Legistar I.D. #22834
1702 Hoffman Street
Conditional Use Alteration Request

Requested Action: Approval of an alteration to an existing conditional use for the construction of a new building, the Protective Services Education Center for the Madison College Truax Campus, on a portion of an existing surface parking lot in the M1 (Limited Manufacturing) District.

Sidewalk to be removed

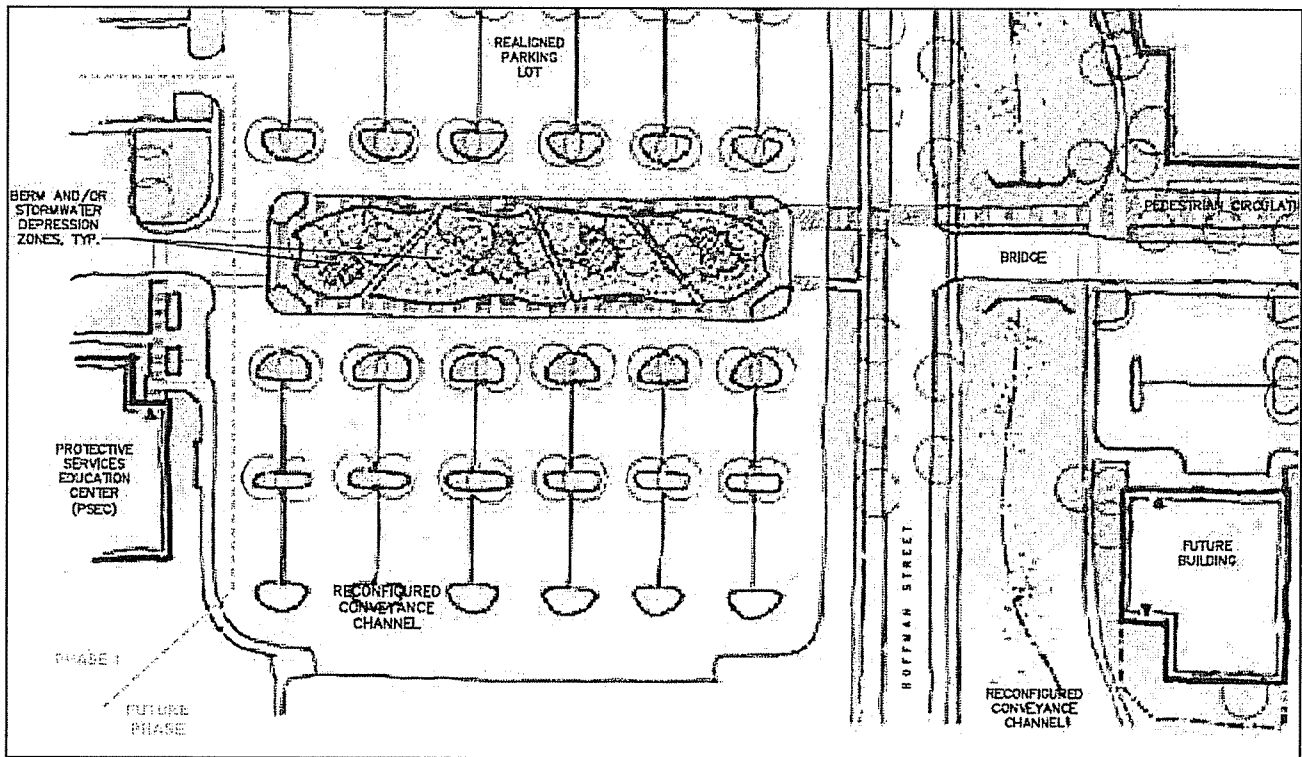
The applicant has indicated that the doors on the southwest corner of the building were included as a means of emergency egress. Rather than providing direct access to this entrance from Anderson Street, the applicant would prefer to remove the existing sidewalk leading from Anderson Street to the southwest corner of the existing parking lot (see right).

Staff believes that while still important to strengthen the pedestrian connection between Anderson Street and the main entrance on the eastern part of the building, it is not as important to create an additional connection at this location, since this entrance will not be used frequently.

- 1. Final plans submitted for review and approval by Planning and Urban Design staff shall show a strengthened pedestrian connection between Anderson Street and the main entrance of the building. The applicant is strongly encouraged to provide a direct pedestrian connection from Anderson Street to the secondary entrance on the southwest corner of the building.
2. The applicant shall work with Planning and Urban Design staff to address the Urban Design Commission recommendation to reduce overall pavement by eliminating one of the two parallel drive aisles just east of the building, if possible within the framework of fire access requirements.

### Condition No. 2 Discussion

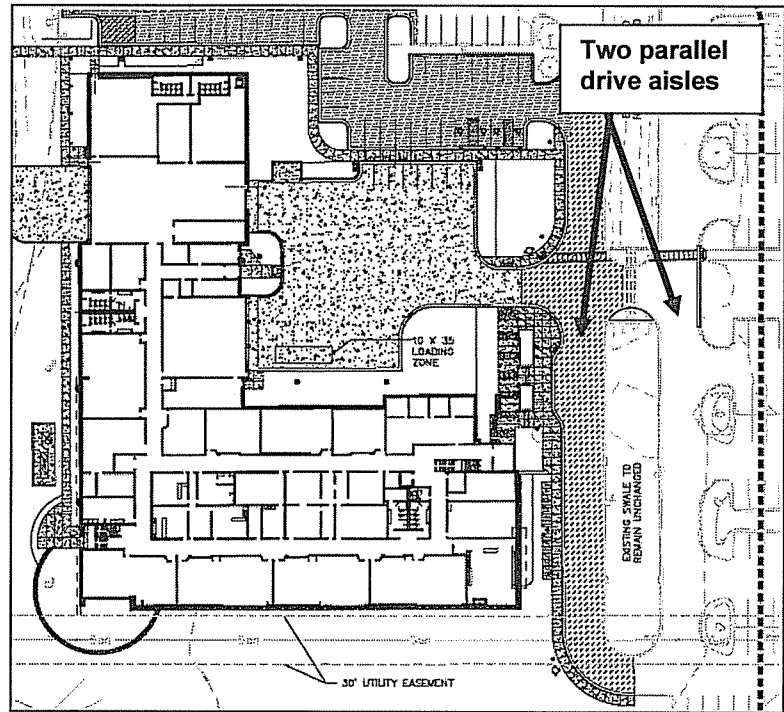
The applicant has indicated that Madison College would strongly prefer to maintain the proposed drive aisle arrangement as shown, until such time as the parking lot surrounding the proposed facility is substantially reconfigured at a later date (see sketch below)

After further consideration, staff believes that this is a reasonable approach at this time. Importantly, there is little or no impervious surface being added to the site as part of this proposal. The eastern of the two drive aisles would remain as it exists today, and the western drive aisles would be reconstructed in place to serve as an aerial fire access lane for the east side of the building.
